Subject: REVISION: N242468490-02 - Service Update
Missing Chassis Harness Plugs
Revised Population, Parts Information, & Service Procedure

Models: 2024 – 2025 Chevrolet Blazer EV

N242468490 Missing Chassis Harness Plugs

Revision: 02

(1) X610 Body Wiring Harness to Chassis Rear Wiring Harness (X0D / X0E)
(2) J491 Chassis Rear Wiring Harness (X0D / X0E)

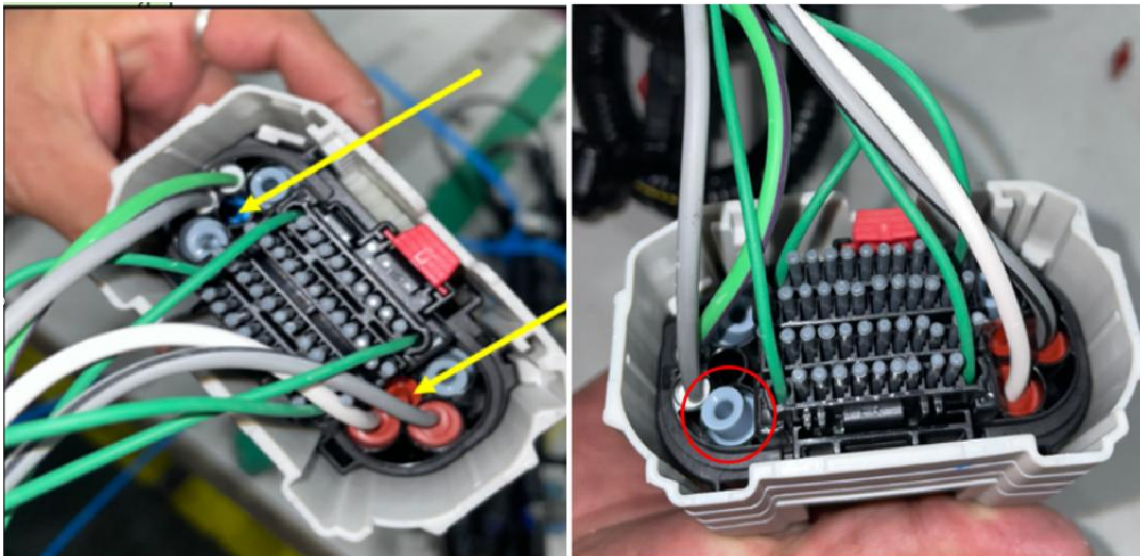
Revision Description: This bulletin has been revised to remove the procedure to inspect and repair vehicles with a 36 way chassis harness connector (RPO XOB or XOC). These vehicles will be removed from the population, as inspection is no longer necessary.

4. Locate and inspect X610 Body Wiring Harness to Chassis Rear Wiring Harness. Verify there is no corrosion within the connector.

5. Inspect ALL blue and red cavity plugs to ensure they are seated flush and centered within the connector body.

4.1 If corrosion is found at either connector, replace the corroded terminals and thoroughly clean the connector. Refer to *X610 Body Wiring Harness to Chassis Wiring Harness* in SI for terminal location and proper tools. Refer to *Wire and Connector Repair* in SI for further instruction.

4.2 If no corrosion is found, clean and dry the connector and proceed to the next step.

5.1 If any of the cavity plugs **PROTRUDE** as indicated in the image above, use a small round or flat bladed tool to insert them correctly into the connector. Ensure the cavity plug seats flush and centered within the connector.
